RE: Axis Midstream
 Redfish to Harbor Island Pipelines

SUBJECT: SWG-2018-00789; Axis Midstream, Midway to Harbor Island Pipeline and Facilities, Application Meeting

SUBJECT: Permit Application: SWG-2018-00789

RE: PERMIT APPLICATION – SWG-2018-00789
Axis Midstream Holdings, LLC – Midway to Harbor Island Pipelines & Support Facility
Proposed Pipelines and Support Facilities
San Patricio and Nueces Counties, Texas

DWG. NO. HDD-01

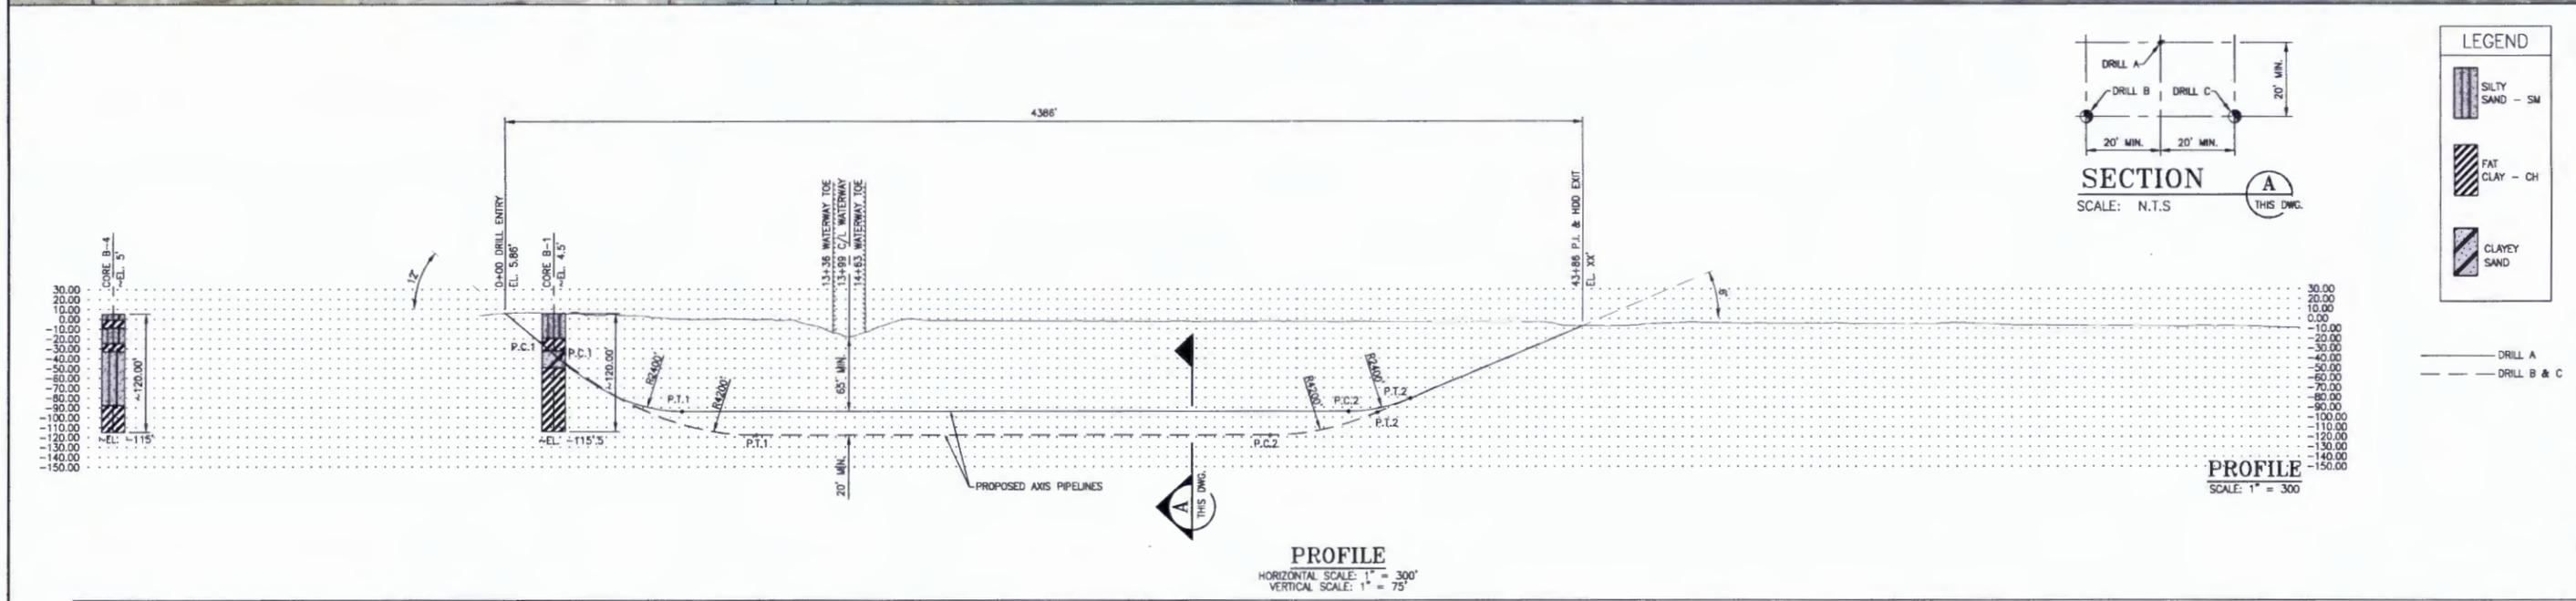
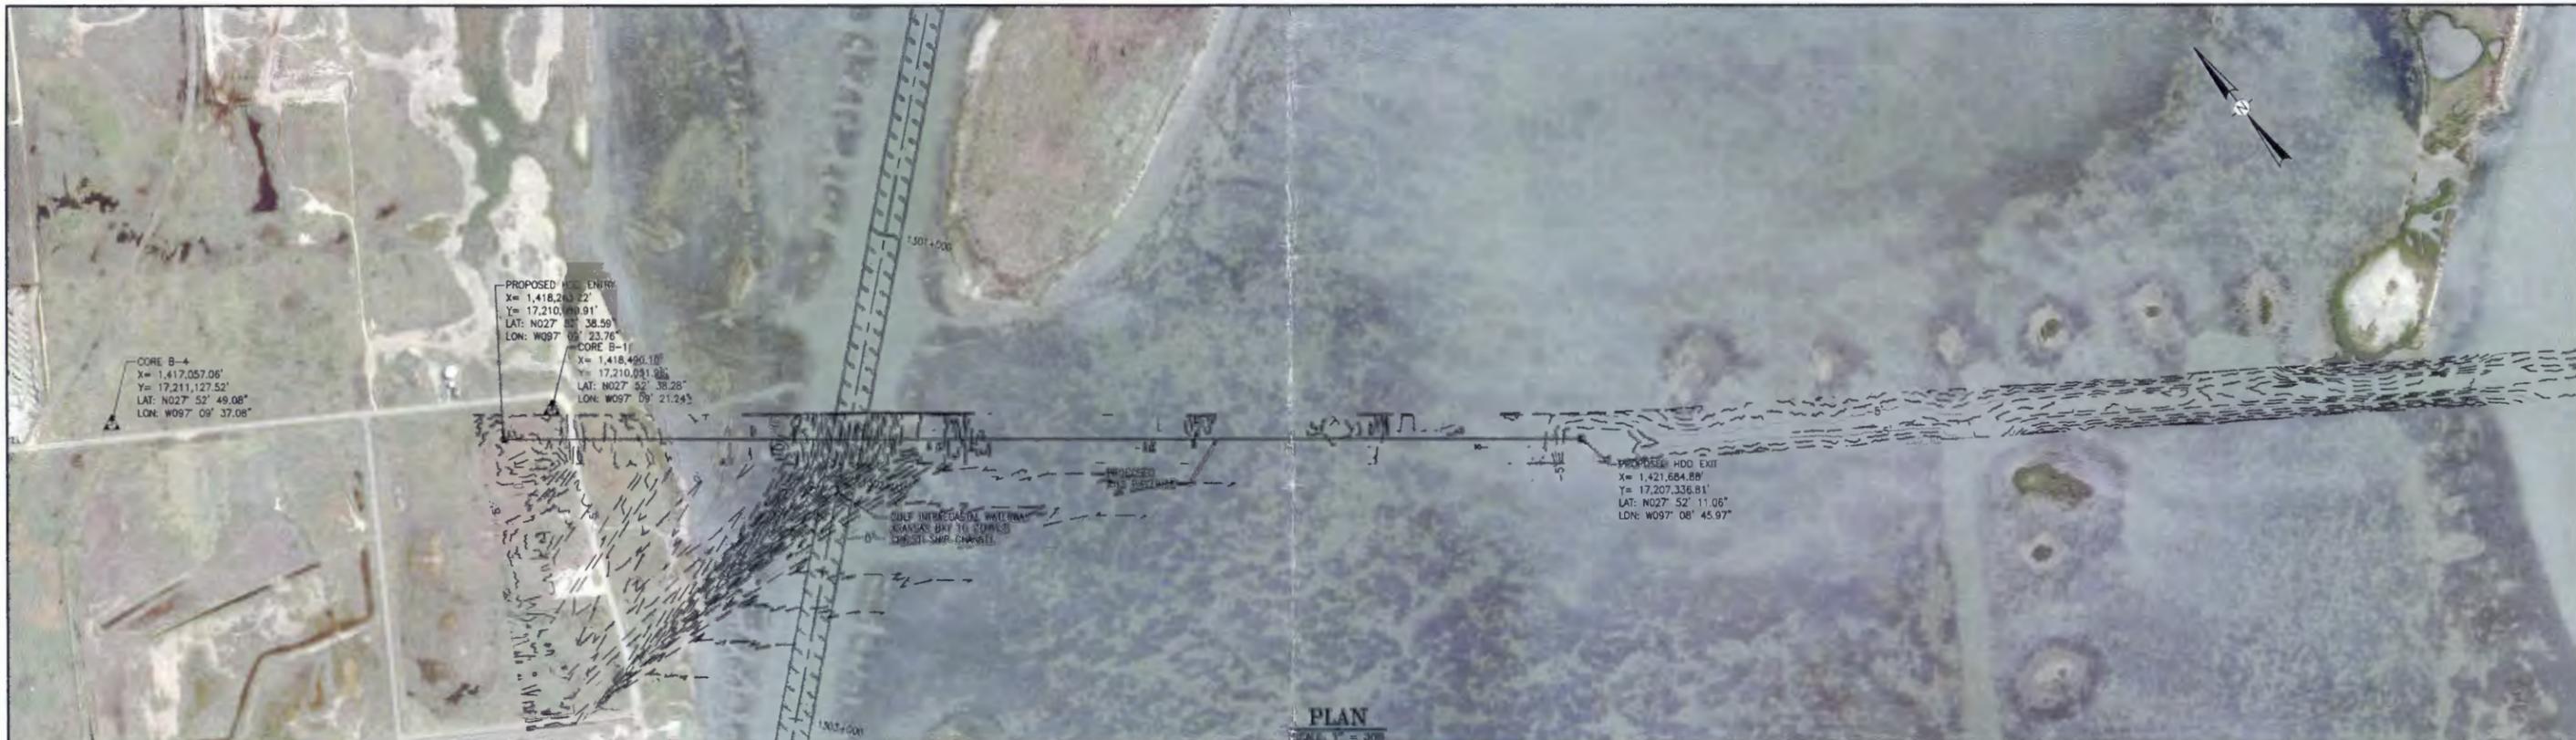
e. HDD Workspaces: This was not annotated on the project plans. Additionally, it was not specified that where the entry and exit points are located. They will address this with revised plans.

2. It was brought to our attention that there may be a potential second 42-inch crude oil pipeline added to the route between the proposed Midway Facility and the Redfish Facility. Additionally, it was unclear where the temporary work area for the horizontal directional drilling (HDD) locations would be to cross the GIWW and how the pipeline would be installed across Redfish Fish Bay. There were also other inconsistencies with the proposed permit drawings that were addressed that included, but not limited to temporary placement of fill locations in Redfish Bay, temporary work areas in Redfish Bay, and installation or construction description of how the pipeline would be installed in Redfish Bay. It is unclear what the order of construction would be as well. We require:

- a. Revised plan views and side profile views of the proposed project's drawings.
 - b. The plan views need to be specific enough to identify what is being constructed and what resources are being impacted. Methods of construction should also be detailed on the plan views for the proposed pipelines. We will also accept profile plan views for the construction of the pipelines as long as they are legible (font no smaller than 10).
